RE: **Recall Campaign Launch Notification**  
**Check Mounting of Driver's Seat**  
**MY20 167(GLE-Class)**

Campaign No. 2020080010, August 2020

SUBJECT: **Model GLE vehicle (167 platform)**  
**Model Year 2020**  
**Check Mounting of Driver's Seat**

Figure 1

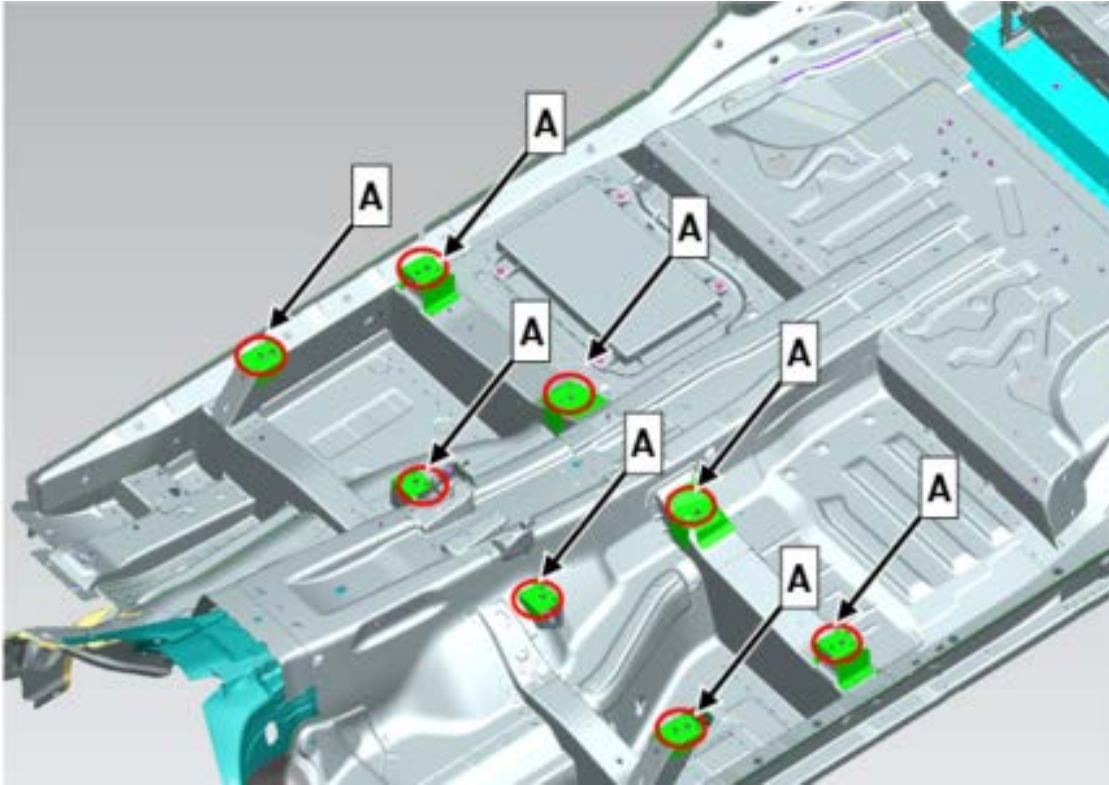
1. Remove driver's seat and as an additional precautionary method check the front passenger seat **AR.91.10-P-1000ME**.
2. Check all eight (x8) bolting points for Helicoil thread insert (**A, figure 1**).

- a. Helicoil thread insert (A) present: Perform **work procedure**.
- b. Helicoil thread insert (A) **not** present: **End measure**.
